Commonwealth Edison
1400 Opus Place
Downers Grove, Illinois 60515

December 13, 1990

Subject: Braidwood Station Units 1 and 2
Inservice Inspection Program (ISI)
NRC Docket Nos. 50-456 and 50-457

RELIEF REQUEST NR-12

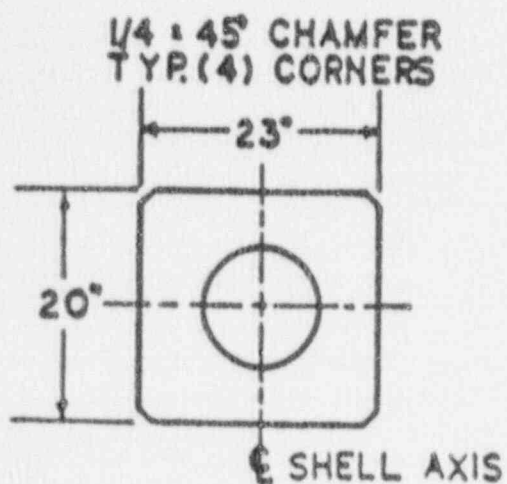
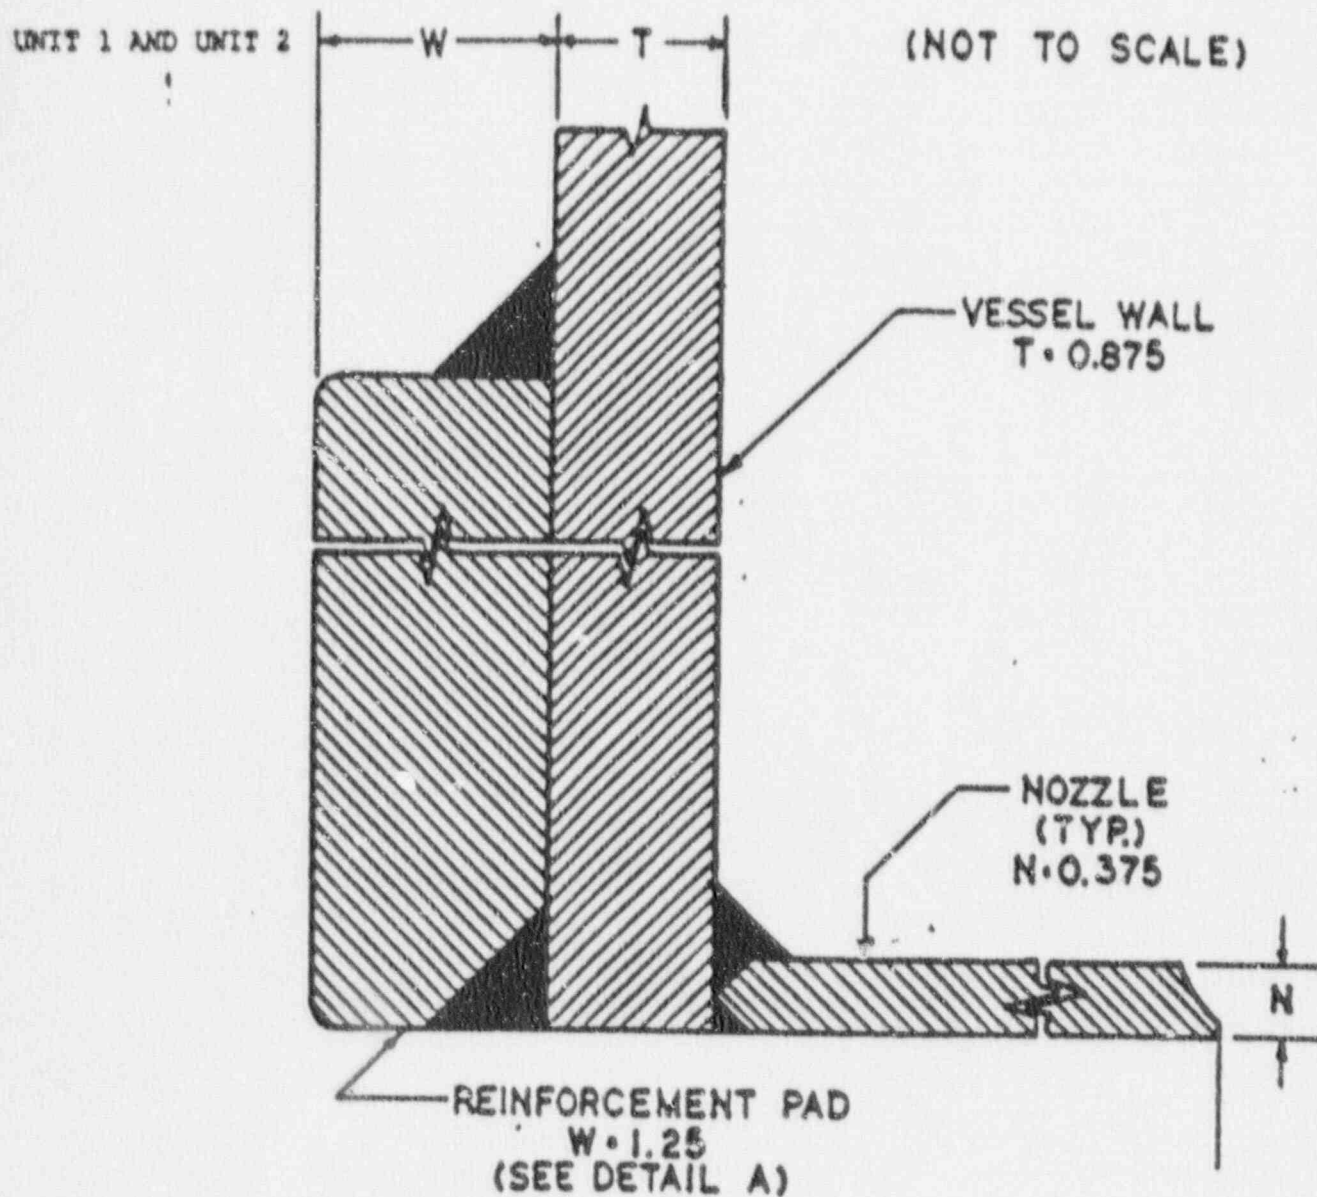
3. A.S.M.E. CODE CLASS: 2
4. A.S.M.E. CODE SECTION XI REQUIREMENTS: Subsection IWC, Table IWC-2500-1, Examination Category C-B, Item C2.22 requires volumetric examination of the nozzle inner radius and Item C2.21 requires volumetric and surface examination of the Nozzle to Shell weld of the regions described in Figure IWC 2500-4(a) or (b), for nozzles without reinforcing plate in vessels >1/2 in. nominal thickness. Examinations shall be conducted on nozzles at terminal ends of piping runs selected for examination under Examination Category C-F, each inspection interval.
5. BASIS FOR RELIEF: The nozzles listed above contain inherent geometric constraints which limit the ability to perform meaningful ultrasonic examinations.

The Residual Heat Removal Heat Exchanger is approximately 7/8 in. nominal wall thickness with nozzles of 1 1/4 inch diameter and approximately 3/8 in. in nominal wall thickness. The configuration is best characterized as a fillet welded nozzle using an internal reinforcement pad and, thereby is not analogous to a full penetration butt welded nozzle as shown in Figure IWC-2520-4. In addition, the inner radius of the reinforcement pad would be representative of the nozzle inner radius required for inspection. The inherent geometric constraints of the nozzle design prevent the performance of the required ultrasonic examinations of the nozzle inner radius, see attachment 1. A nozzle-to-shell UT may not achieve full ASME coverage of the weld area.

6. ALTERNATE TEST METHOD: The welds listed above will receive the required Section XI surface examinations. Visual examination (VT-1) of the nozzle inner radii shall be performed either directly or remotely to the extent practical when disassembly is required for maintenance purposes not to exceed once per inspection interval. In addition, visual examination (VT-2) shall be performed each inspection period on all pressure retaining components. A best effort UT shall be performed on the RHR HX nozzle-to-shell welds on a frequency consistent with ASME Section XI.

7. JUSTIFICATION: The VT-1 examination will assure early detection of detrimental flaws. Therefore, in performing the proposed alternative examinations during disassembly for maintenance, an adequate level of structural integrity can be assured for continued plant operation.
